Wollongong Local Planning Panel Assessment Report | 7 May 2024

WLPP No.	Item No. 3
DA No.	DA-2023/173
Proposal	Residential - demolition works and tree removal. Construction of multi-dwelling housing – five (5) dwellings and Subdivision – Strata title
Property	148-150 Farmborough Road, FARMBOROUGH HEIGHTS NSW 2526 & Kotara Crescent, Unanderra
Applicant	House of Planning Pty Ltd
Responsible Team	Development Assessment & Certification Team - City Wide Team (BB)

ASSESSMENT REPORT AND RECOMMENDATION

1 Retaining Wall Plan
1 : 150

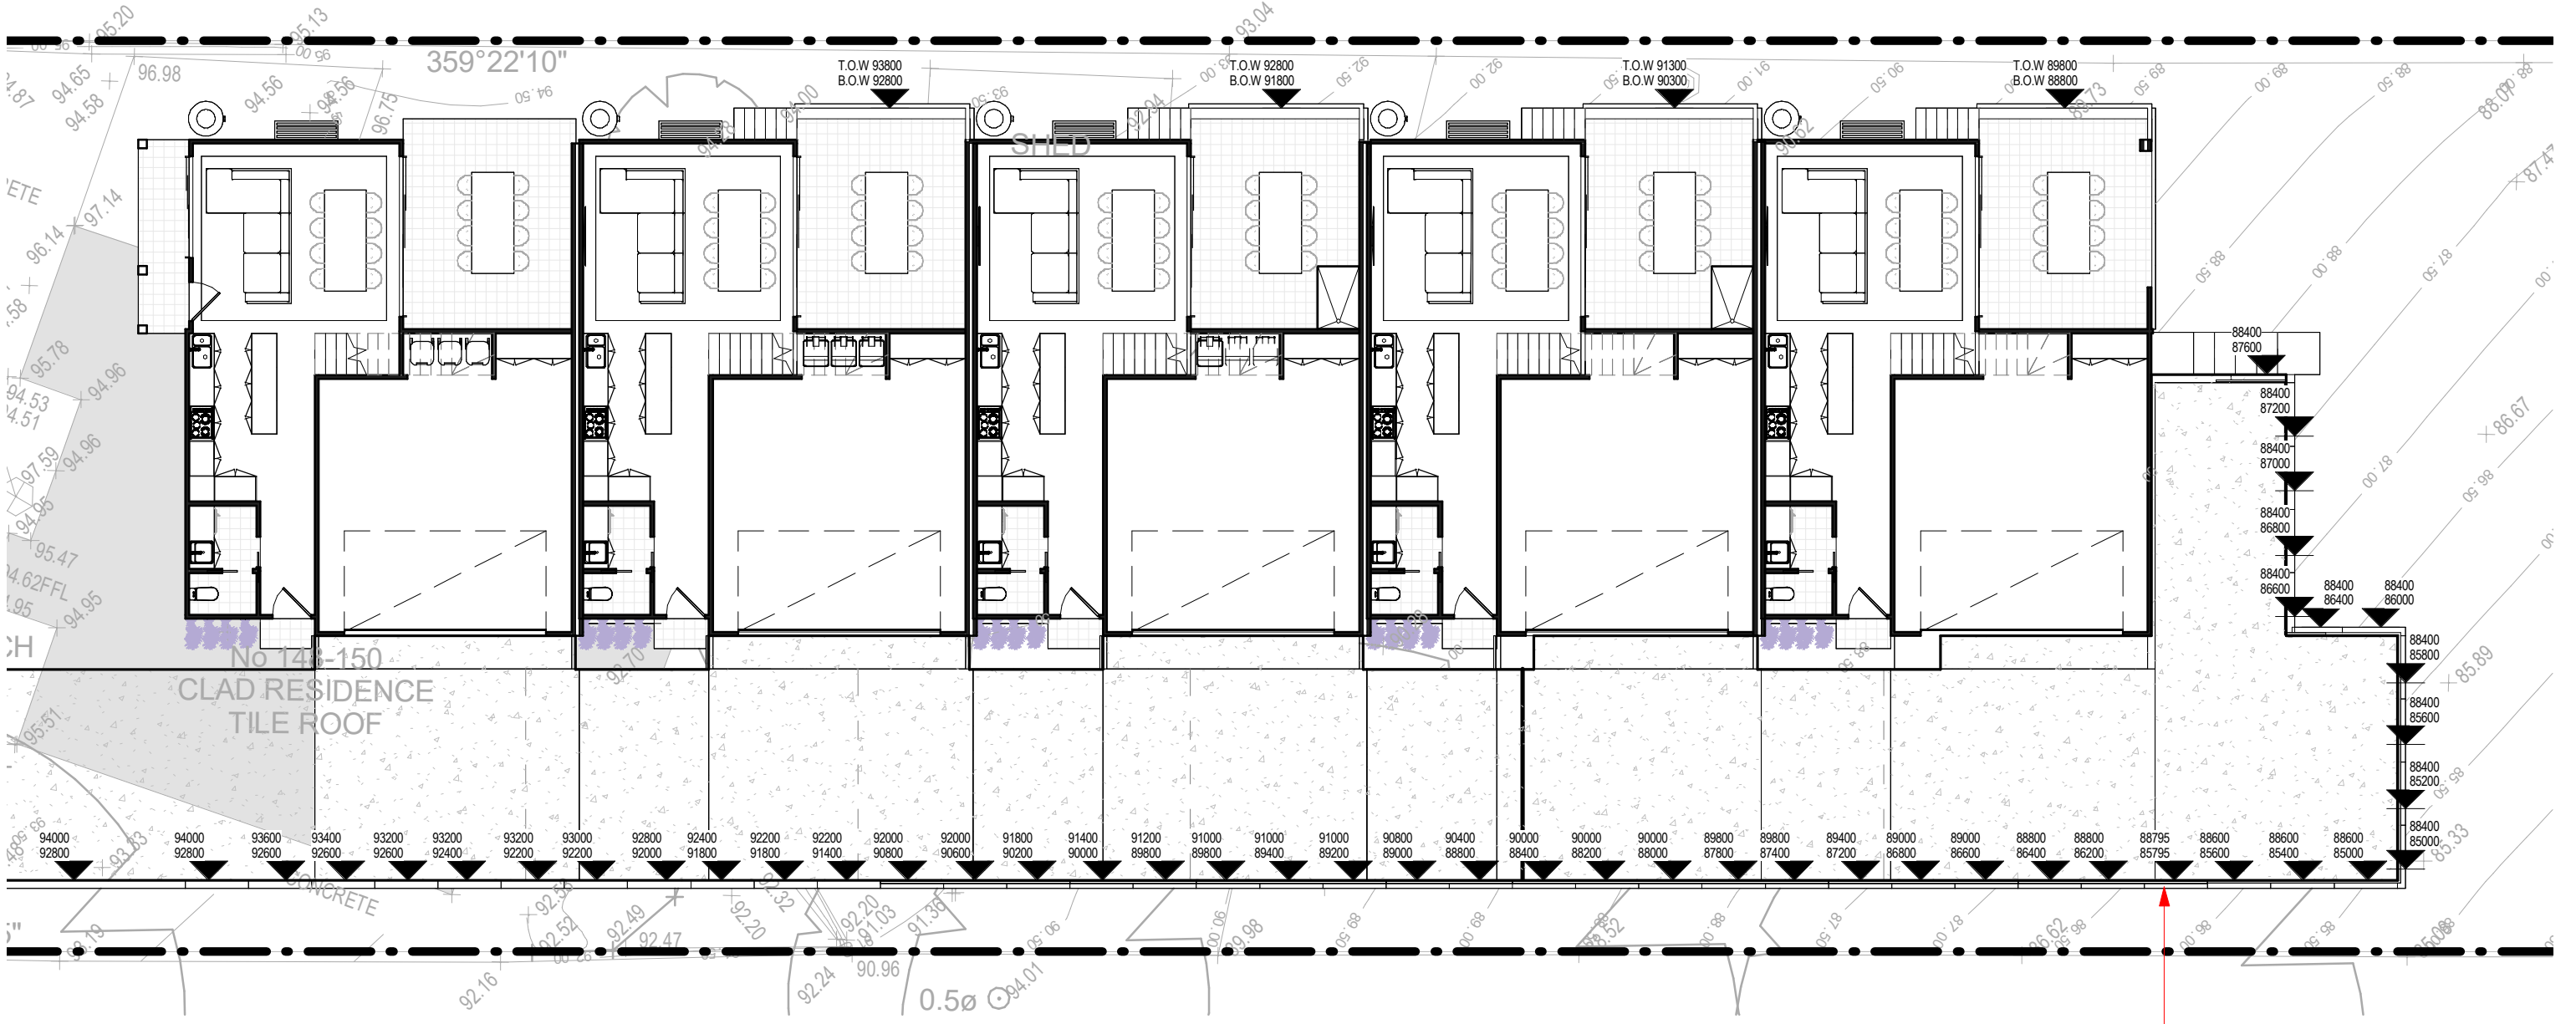
- Retaining walls are excessive in height.
- The parking aisle adjacent to the garage and visitor space is required to be widened that complies with figure 5.4 of ASA2890.1. Obstructions in the parking aisle and narrow door jambs result in the B85 design vehicle hitting walls or porches in the turning manoeuvres as per below;

- Trees on neighbouring properties are impacted on as a result of the proposed development. No consent to remove these have been provided, including those trees impacted by the proposed drainage infrastructure.
- Retaining walls do not comply with objectives or controls in WDCP 2009 section 4,17 – exceeding 3 metres in height.
- Separation between driveway and dwellings are not satisfactory.
- Existing trees are not accurately shown on all documentation provided with the DA submission.
- The submitted arborists impact assessment (AIA) does not meet the minimum standards and has been completed by an arborist who does not have the required qualifications.

STORMWATER LONGITUDINAL SECTION
SCALE (H) 1:100
(V) 1:20

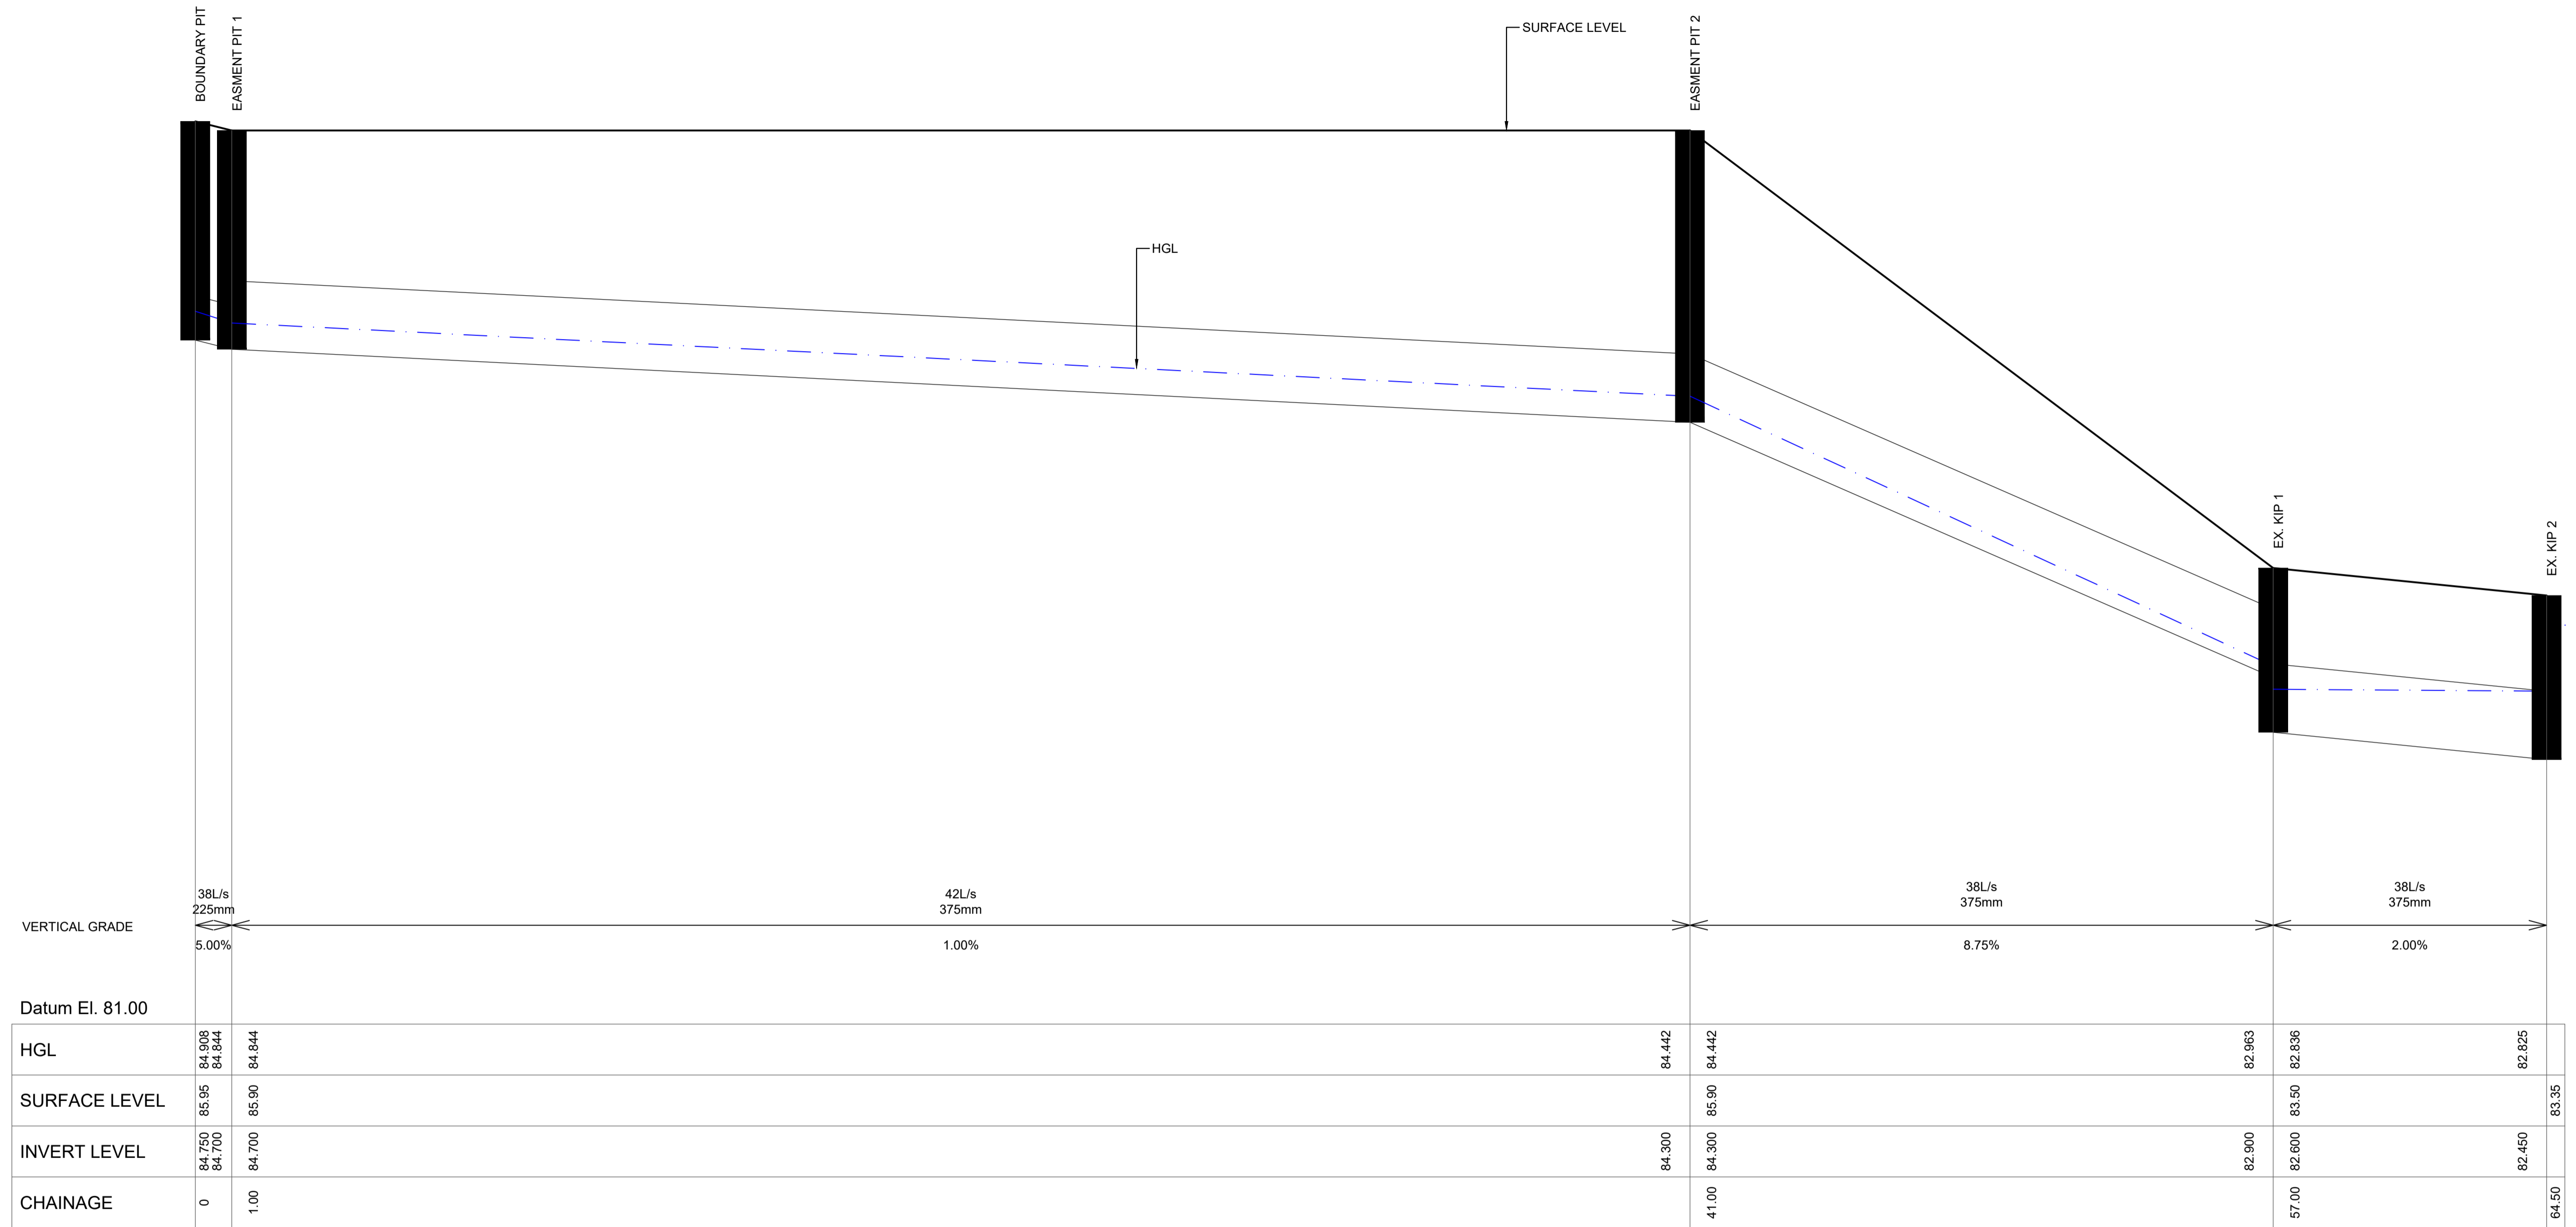
A meeting was held with the applicant, their engineering consultant, a representative from Land and Housing Corporation (LAHC), Council's development project officer and Councils' development engineer on 14 December 2023. The purpose of the meeting was to resolve storm water design elements with respect to achieving alignment with Council's Development Control Plan. The proposal in its current form is not supported by Council as it redirects the flow of catchment without a suitable discharge point.

- The application fails to comply with section 9.3 Disposal of Stormwater from Development Sites Chapter E14 of Wollongong Development Control Plan 2009 as the development site does not have a suitable discharge point.
- Documentary evidence is required to be provided which confirms the downstream property owner agrees to the provision of a drainage easement through their property.

- d. Chapter E14: Stormwater Management; in that the proposal does not comply with section 9.3 Disposal of Stormwater from Development Sites Chapter E14 of Wollongong Development Control Plan 2009 as the development site does not have a suitable discharge point.
